## **Feder Residence**

**2486 Vallecitos Ct, La Jolla CA, 92037**

**Community Planning Group**

SHEET TITLE  
**PROPOSED SITE PLAN**  
**A010**

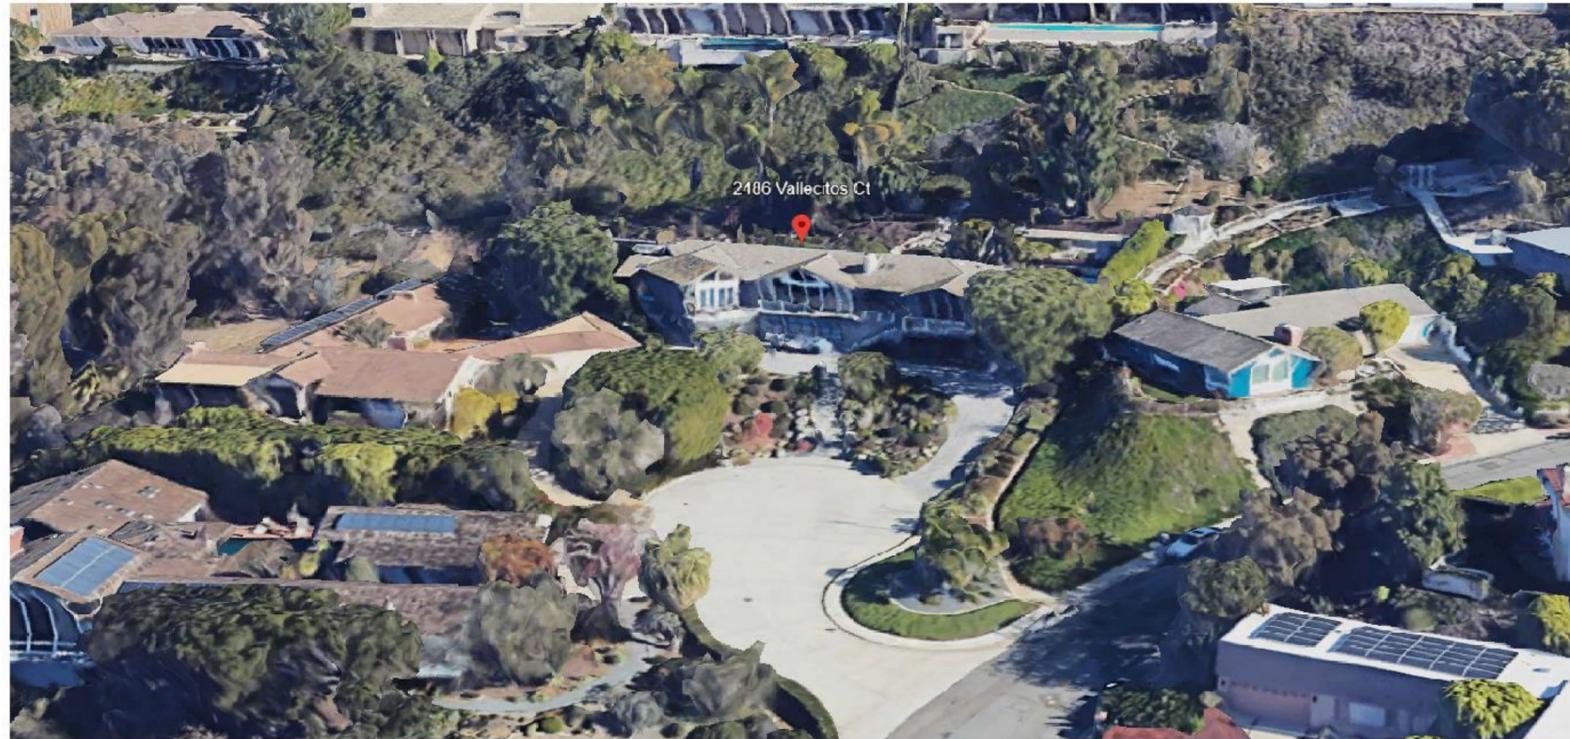
On sheet A010, the Proposed Site Plan, the visibility triangle must be measured along the new property line after the dedication. Please revise accordingly.

On sheet A010, please call out the driveway width.

Landscape Area: Proposed and existing landscape areas on sheet L01 and A010 do not match. Please correct and clarify.

## PROPOSED DRAINAGE PLAN

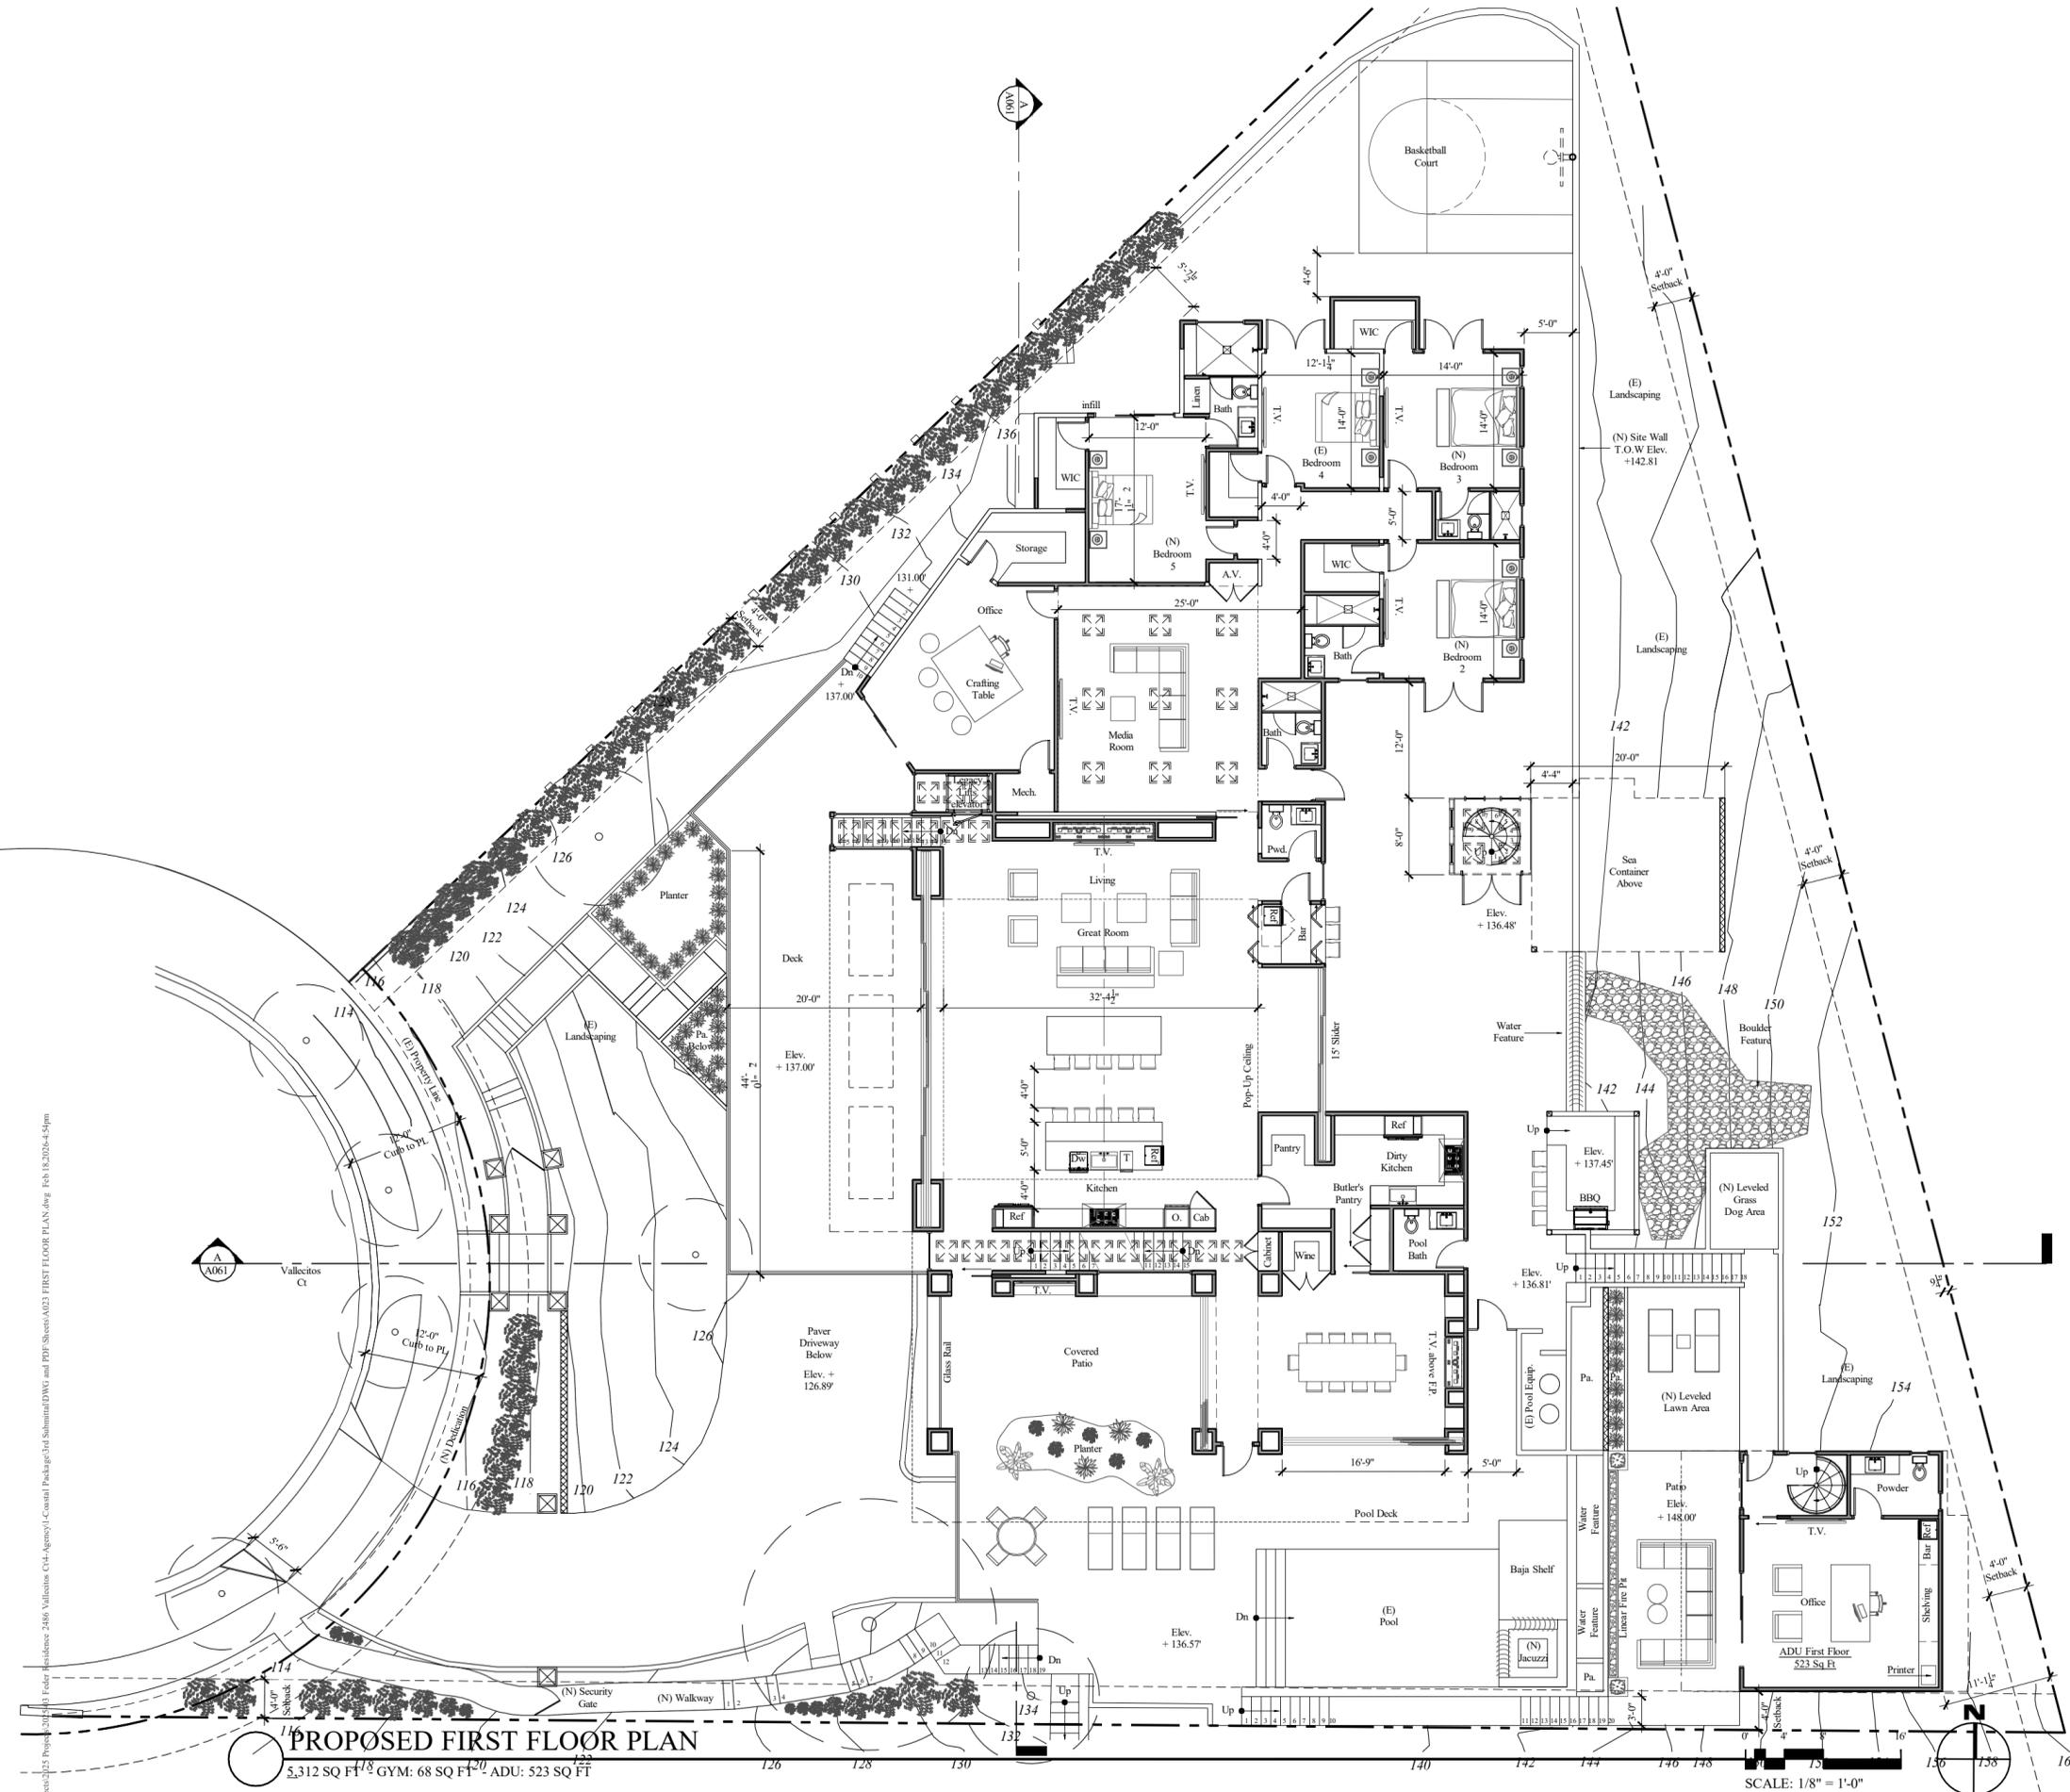
Sheet A012 calls out a 5 ft fill in certain areas. Please revise the building sections to show the locations of maximum fill depths.

SHEET TITLE  
PROPOSED SECTIONS

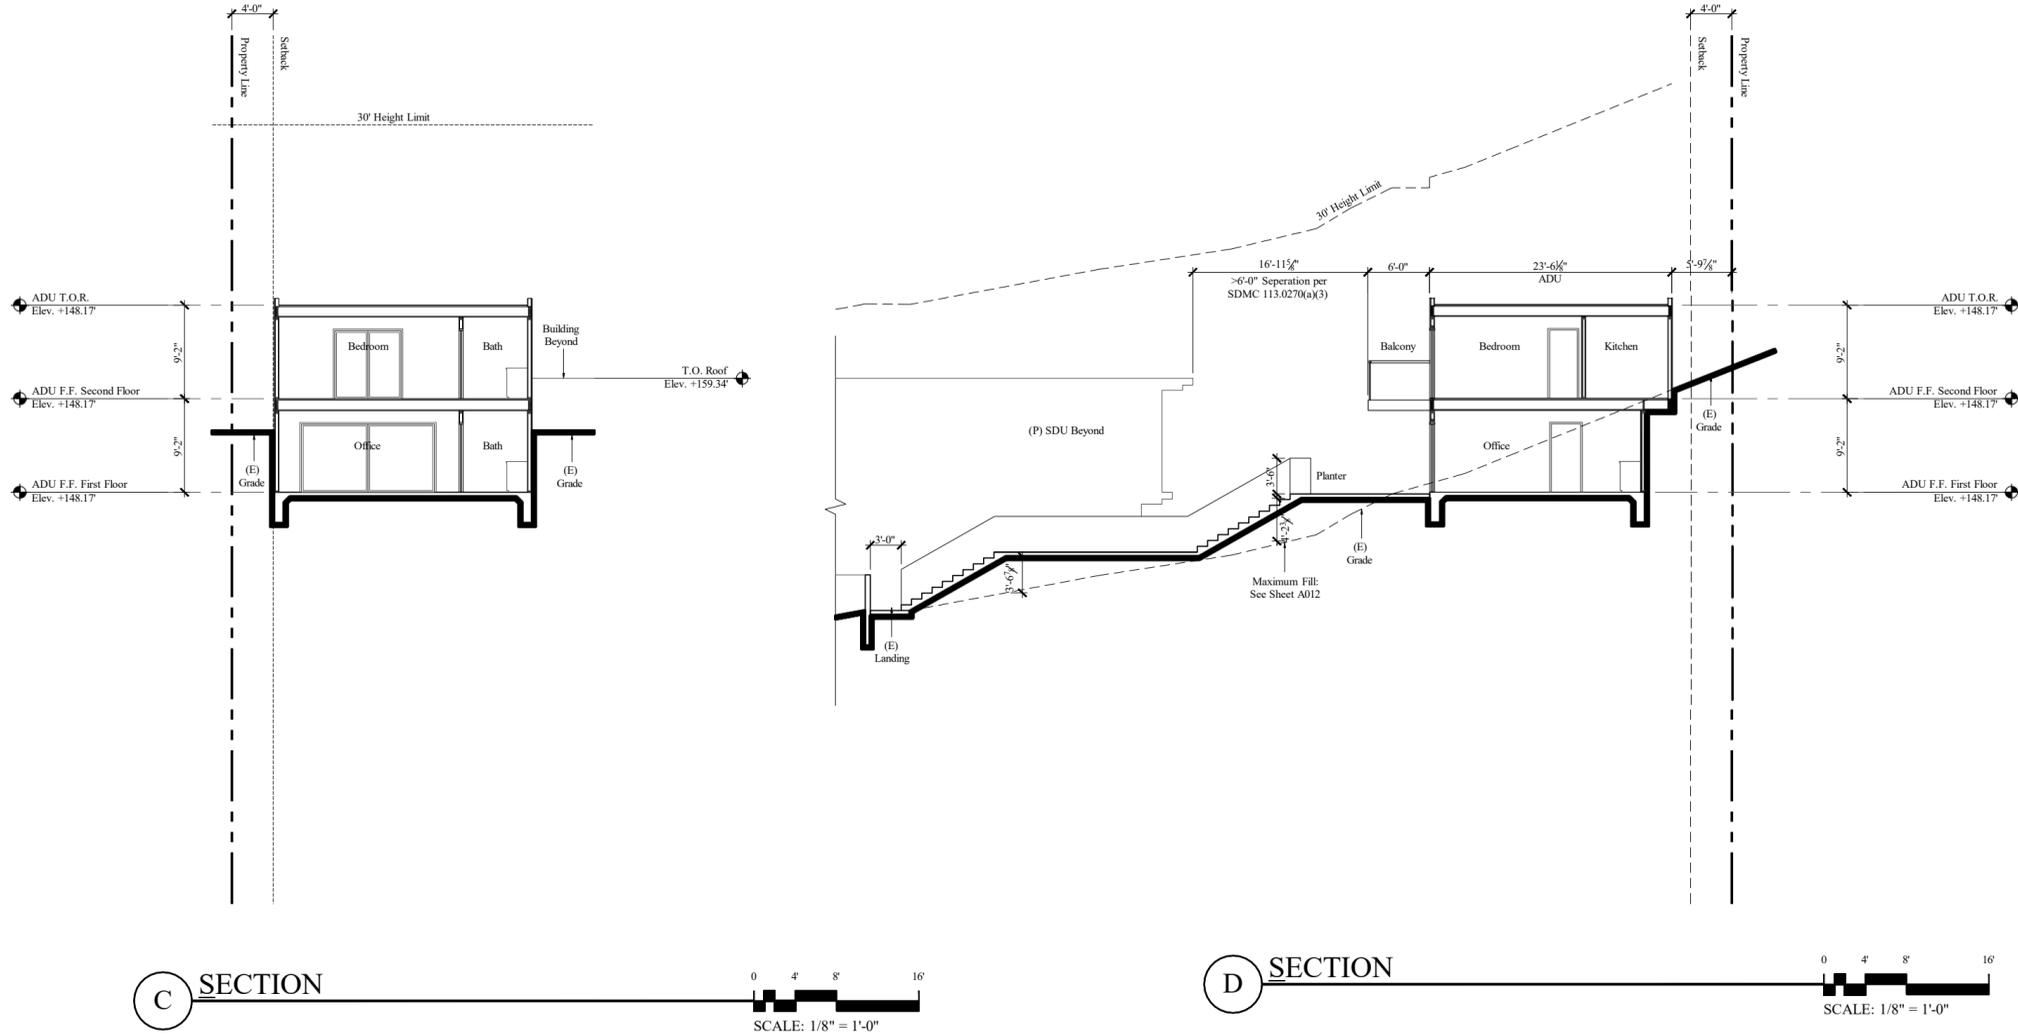
Sheet A061 - The Velux skylights appear to exceed the plumb line height by less than an inch. Please redesign or detail how the structure does not exceed the maximum plumb line height measurement.

Regarding the Plumb Height Section B – Sheet A061, plans currently presents an imaginary plane per SDMC 113.0270(a)(4)(B)(i). However, it is unclear why the measurement is being taken from the interior of the pool bath. Provide further clarification on the measurement since this measurement must be taken from the exterior grade of the pool bath where it is exposed to air and light.
